SUBJECT: **January 17, 2008 Steering Committee Meeting – Agenda Item #3 – Land Use Alternative Review and Consensus**

SUBJECT: Meydenbauer "South of Main" Concept – Emergency Service Considerations

SOUTH of MAIN LAND USE CONCEPT

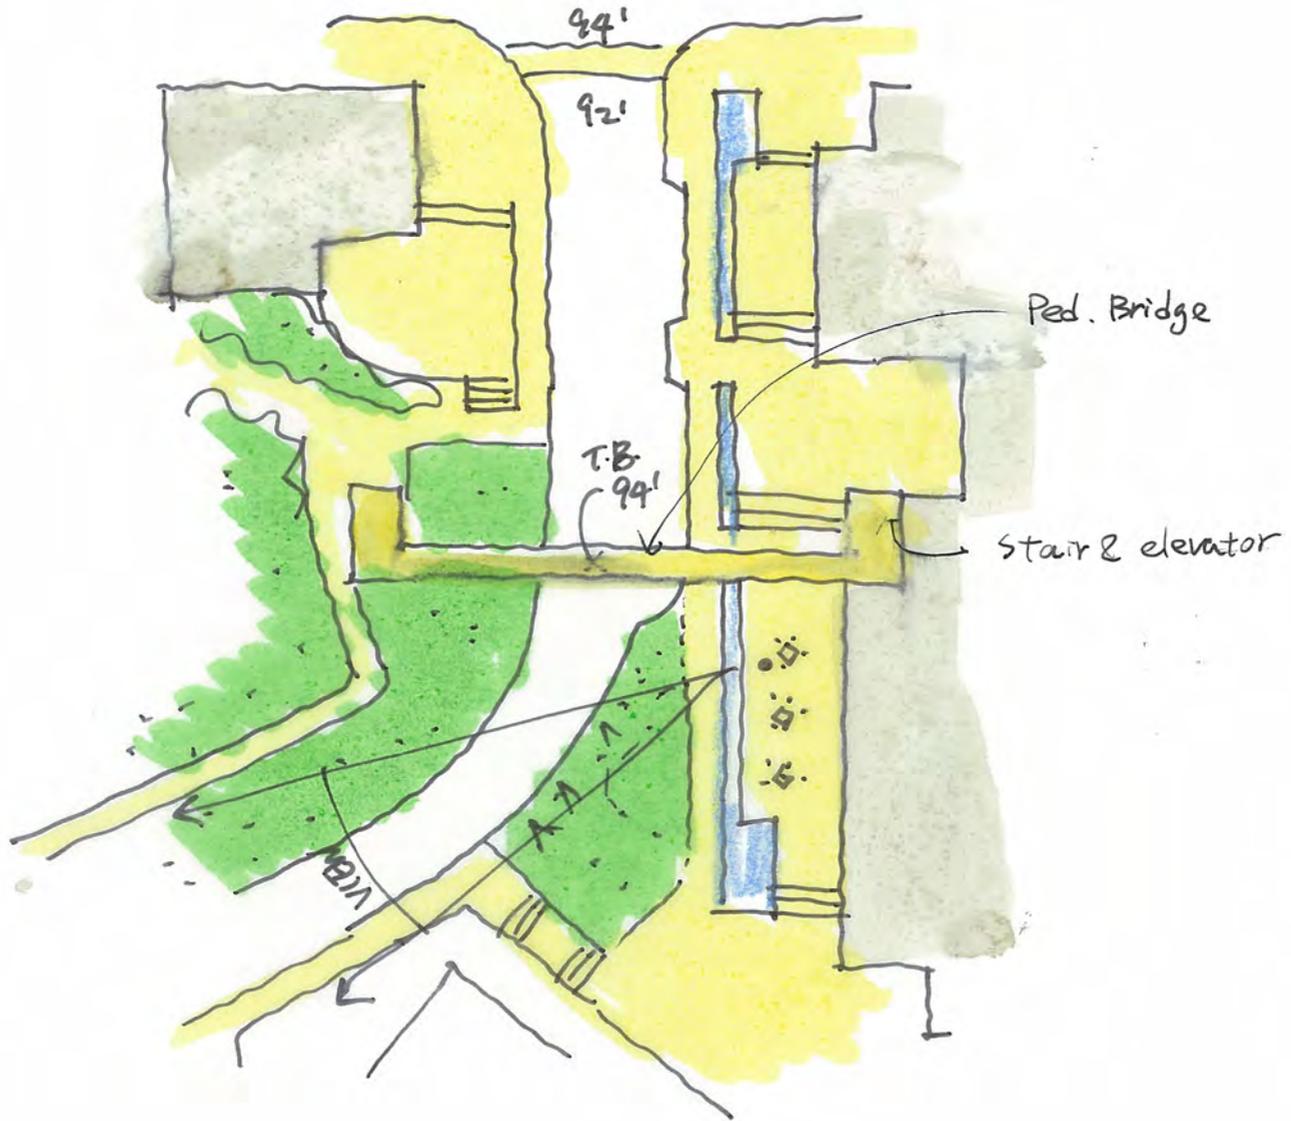
We have reviewed the South of Main concept drawing for the Meydenbauer Bay Park and Land Use Plan dated December 20, 2007. On December 26 we toured the area to gain a better understanding of existing conditions and determine how our ability to provide emergency services to nearby properties might be affected if the concept were implemented.

Overall, we find the concept plan workable from an emergency services standpoint. Even with the potential closure of 100th Ave SE/Bellevue Pl SE to traffic and the dead-ending of Meydenbauer Way SE, emergency services can be provided to existing and future developments, provided that certain features are incorporated into the design of future improvements. As the project proceeds, we recommend that the following be kept in mind:

- 100th Ave SE/Bellevue Pl SE, if closed to vehicles, should provide for some degree of emergency vehicle access, generally consistent with what is indicated on the December 20 concept plan;
- Meydenbauer Way SE can be terminated at Bellevue Place SE and redesigned/resurfaced to create more of a "driveway" or "pedestrian" feel. However:
 - Any reconstruction of the street will need to support fire apparatus loads of at least 64,000 lbs;
 - Minimum clearance widths for fire apparatus will need to be provided. The road should generally be no narrower than that which currently exists along the south edge of Ten Thousand Meydenbauer Condominium.
 - Overhead utilities along the south edge of The Meydenbauer Apartments site should be undergrounded to allow ladder truck clearance and separation from electrical lines.

- Emergency vehicle access should be provided to the south portion of the Vue Condominium site from Meydenbauer Way unless suitable alternate access can be provided. This can be accomplished by the use of opticon-operated bollards at the junction of Meydenbauer Way SE/Bellevue Place SE.

- Parking controls would be needed along roadway edges to not interfere with emergency vehicle access.
 - If through access is not provided, an acceptable turn-around would be needed, per Chapter 3 of the International Fire Code.

- **Building Protection.** Meydenbauer Way SE can continue to provide access for emergency services, including fire suppression and emergency medical services, to adjacent properties. New residential buildings containing three or more units are required to be sprinklered. Ten Thousand Meydenbauer can be protected via ladder truck, provided that the road maintains its existing width. Protection of the Meydenbauer Apartments via ladder truck would be facilitated by the undergrounding of adjacent utilities. The Vue Condominium can be accessed and protected as described above.
